COUNTY OF SAN MATEO
RECONSTRUCTION OF SEVENTH AVENUE FROM MIDDLEFIELD ROAD
TO EDISON WAY IN THE NORTH FAIR OAKS AREA
COUNTY ROAD NUMBER 561-A

COUNTY PROJECT NO. RW703
PROJECT FILE NO. E4957000

ADDENDUM NO. 2

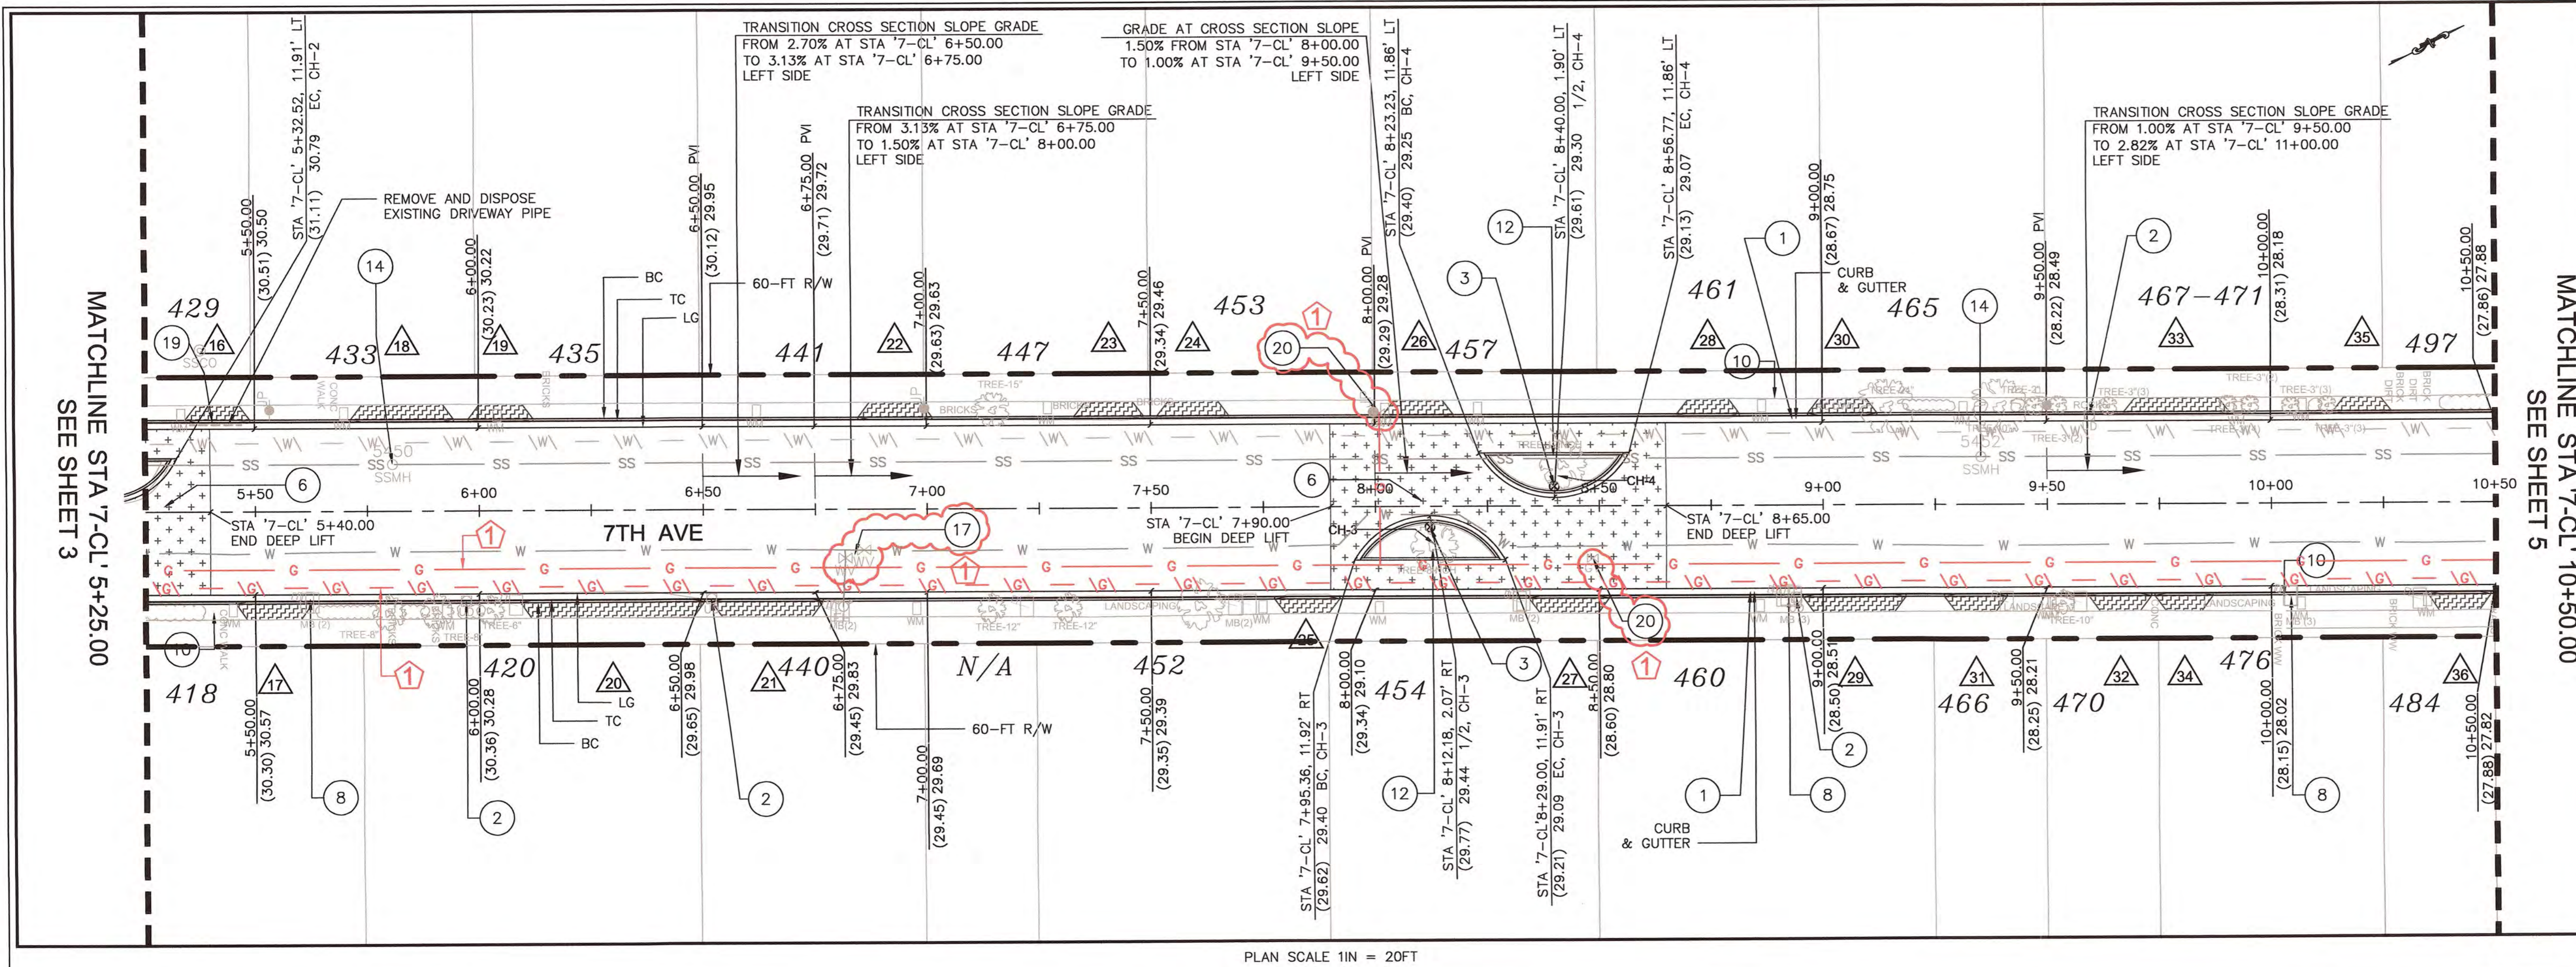
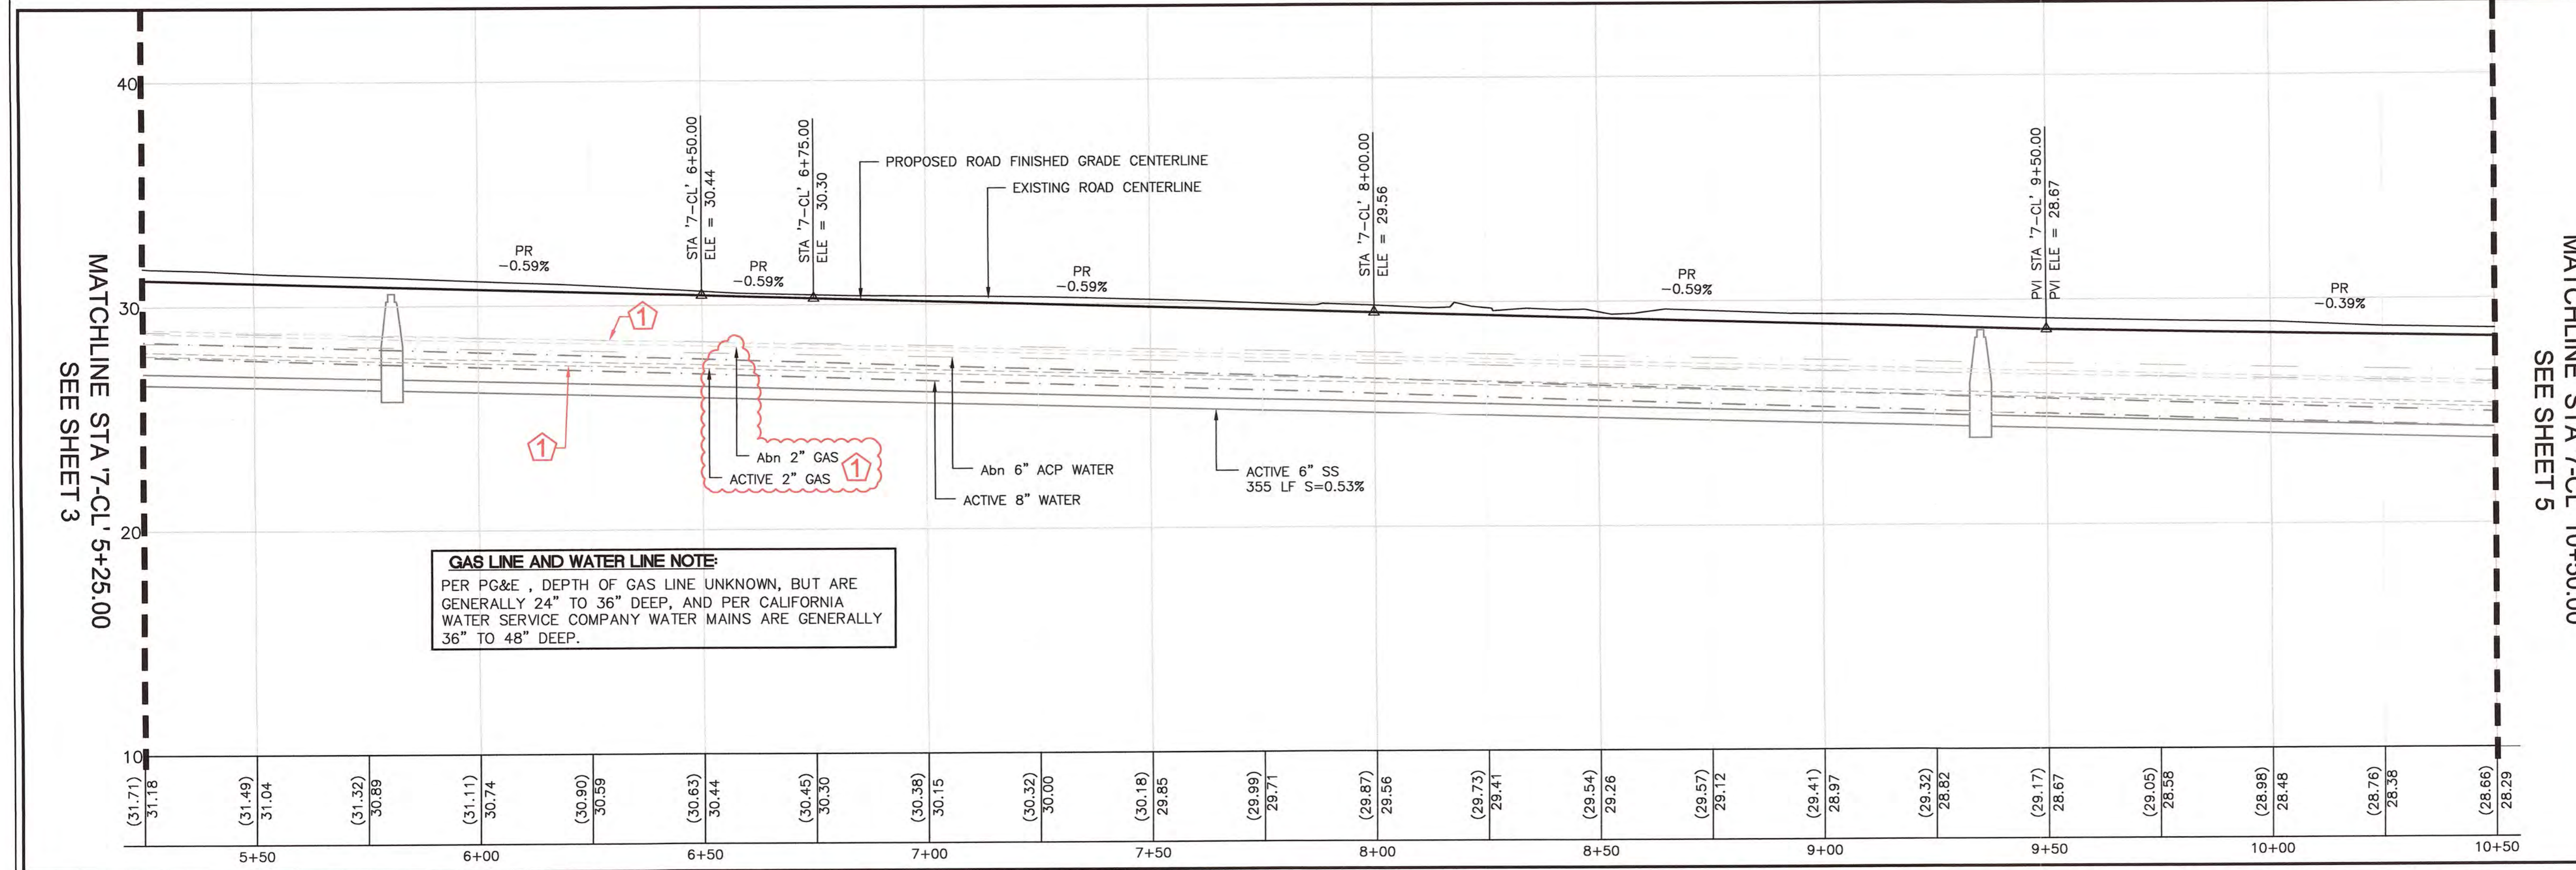
UPDATES:
 1.) HATCH PATTERNS DARKNESS ADJUSTED TO MATCH THE PLAN AND LEGEND
 2.) "ASPHALT CONCRETE" LABEL CHANGED TO "MISCELLANEOUS ASPHALT CONCRETE" LABEL

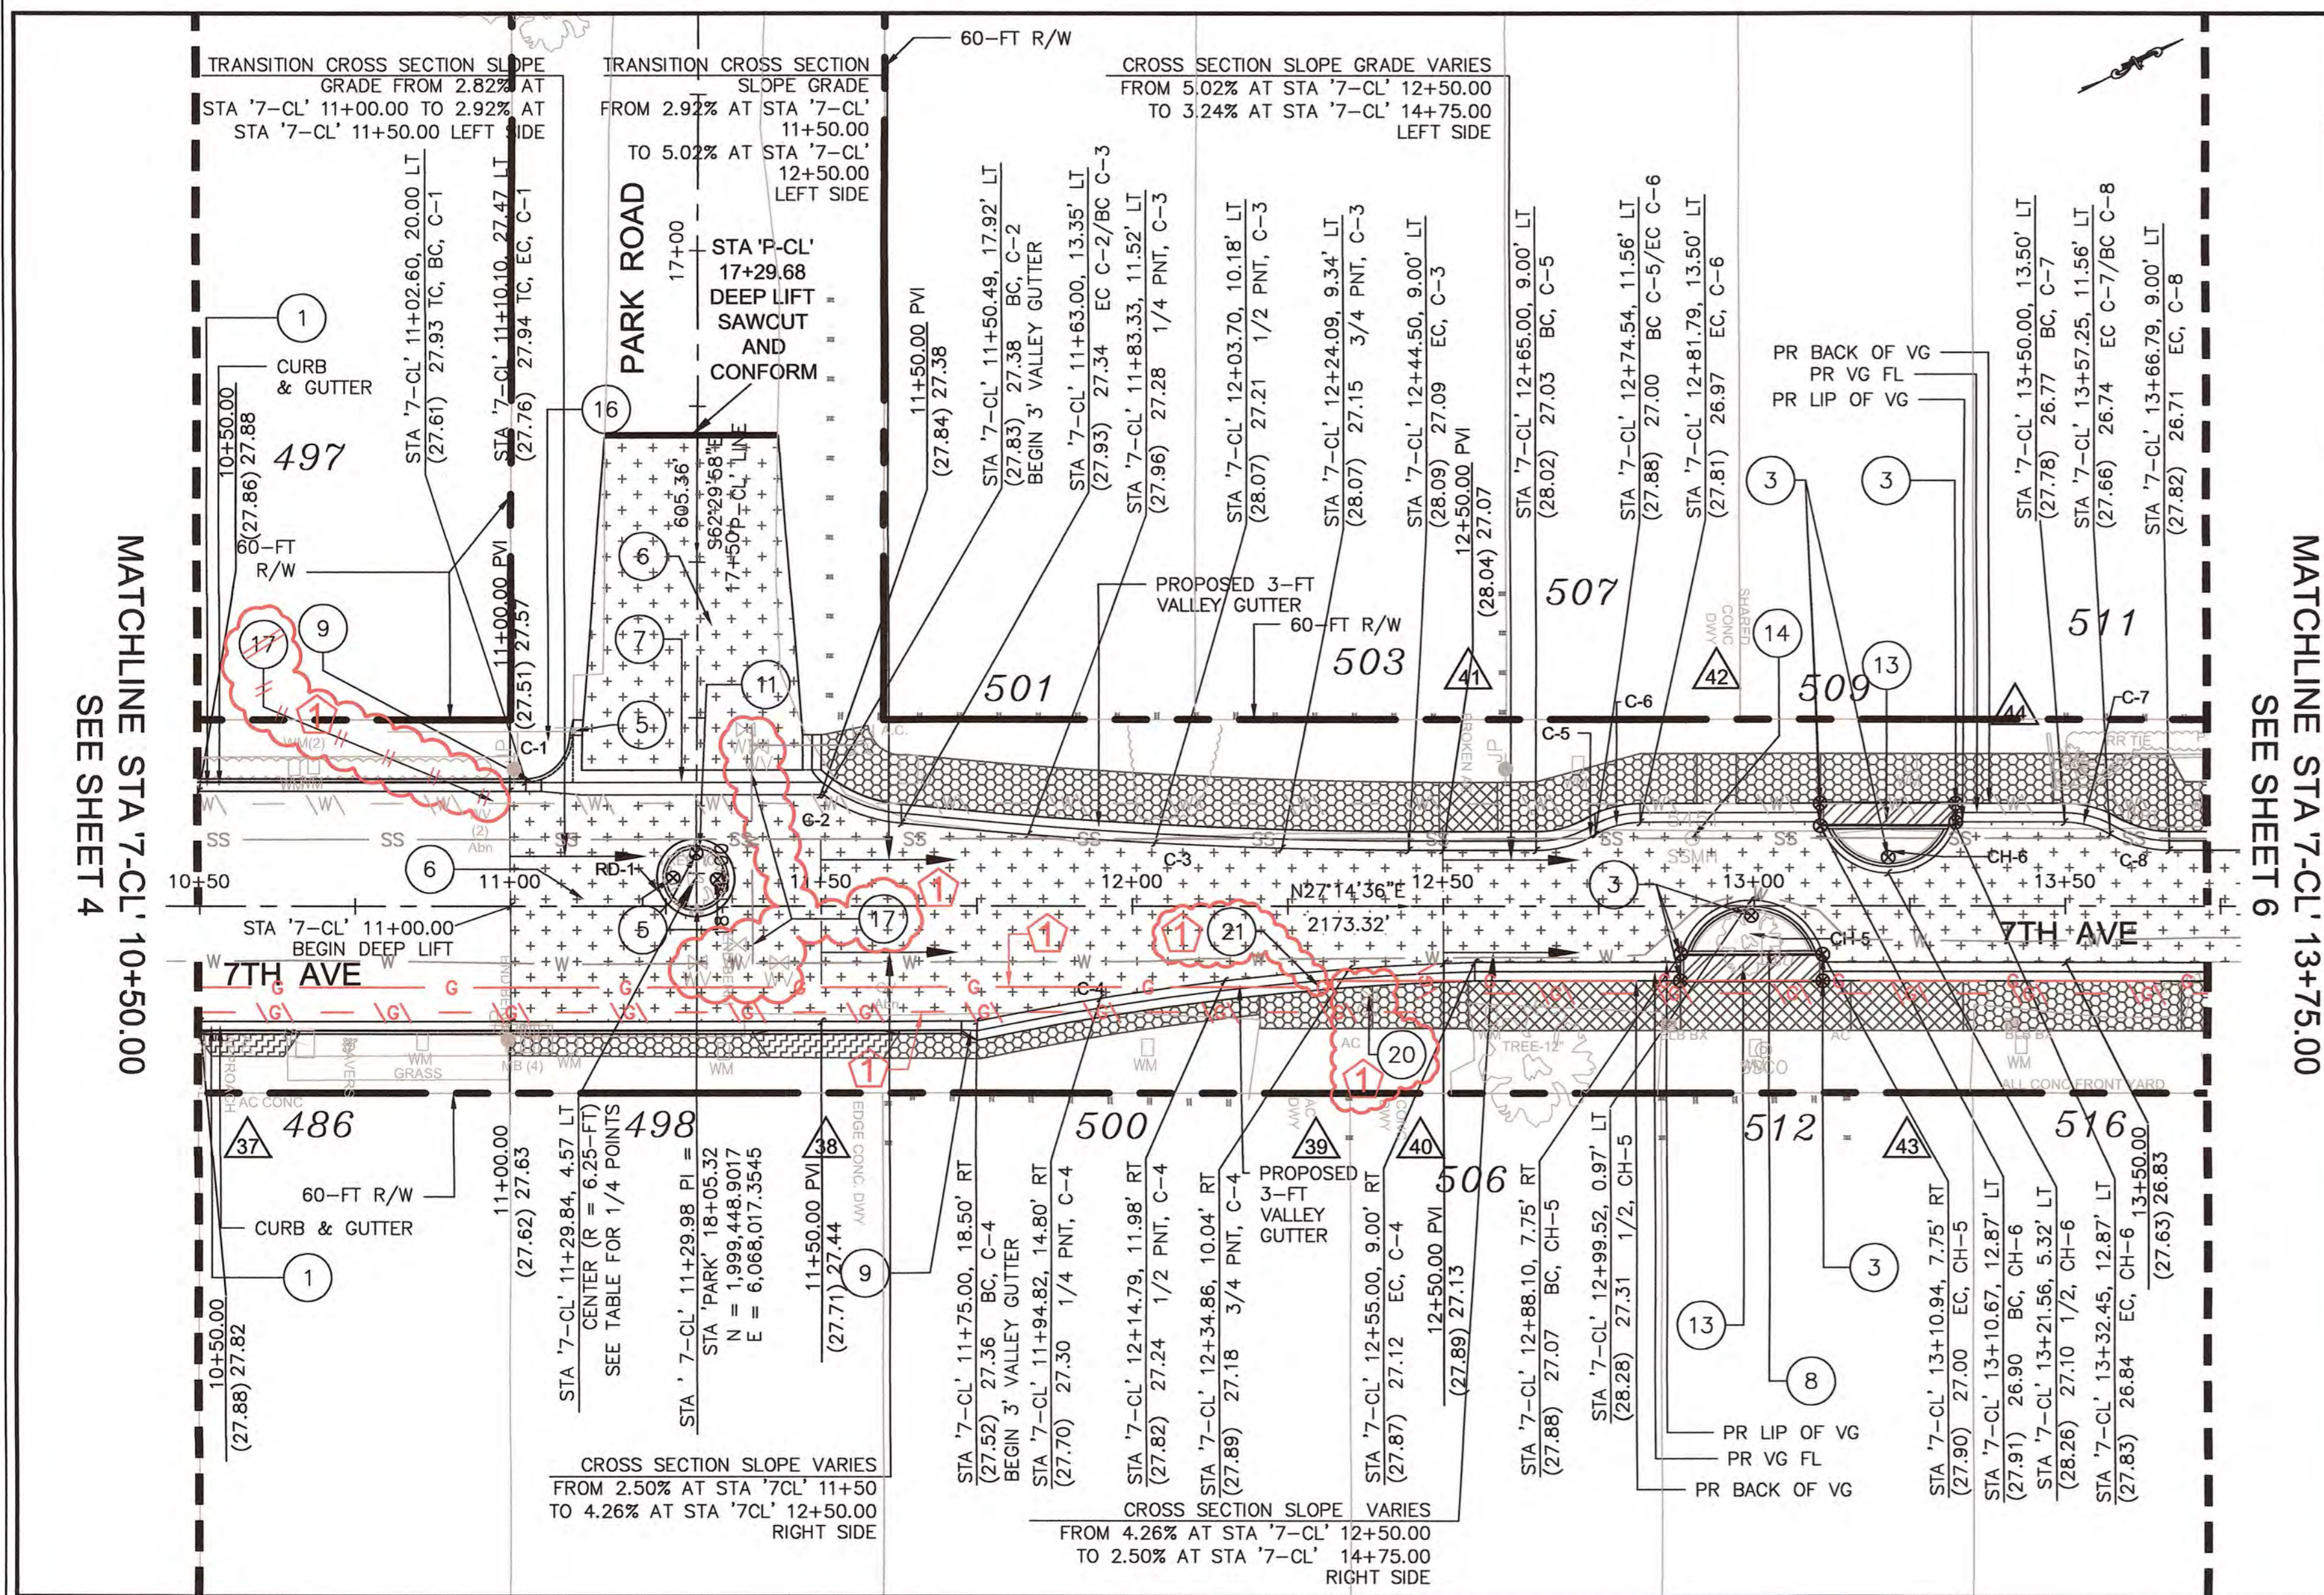
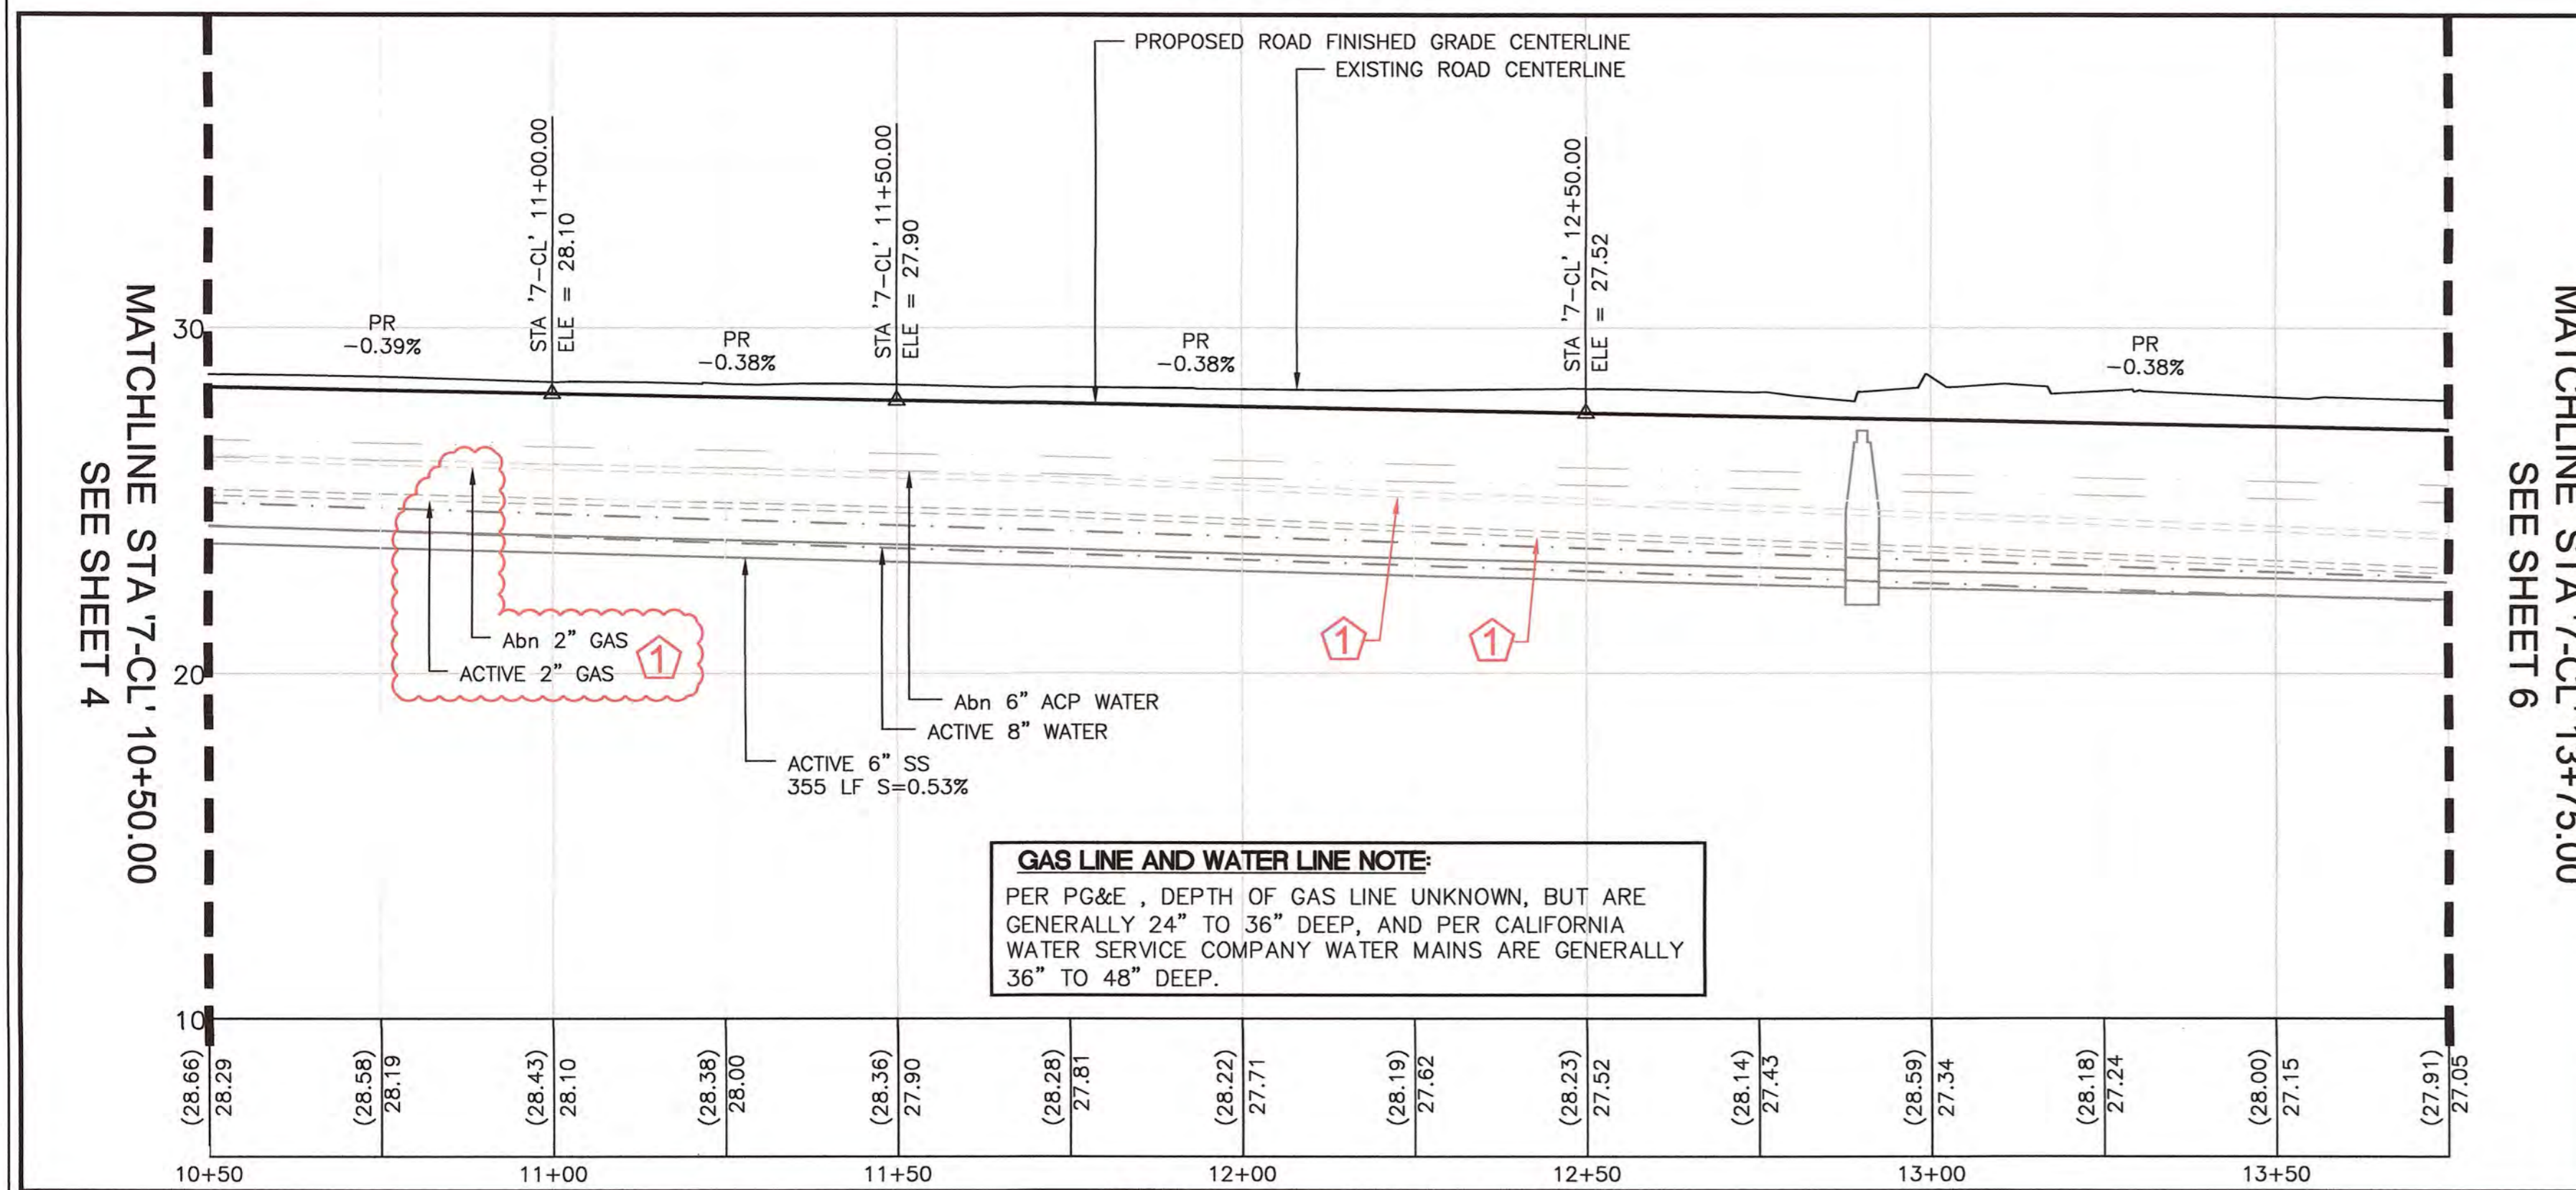
UPDATES:
1.) HATCH PATTERNS DARKNESS ADJUSTED TO MATCH THE PLAN AND LEGEND
2.) "ASPHALT CONCRETE" LABEL CHANGED TO "MISCELLANEOUS ASPHALT CONCRETE" LABEL
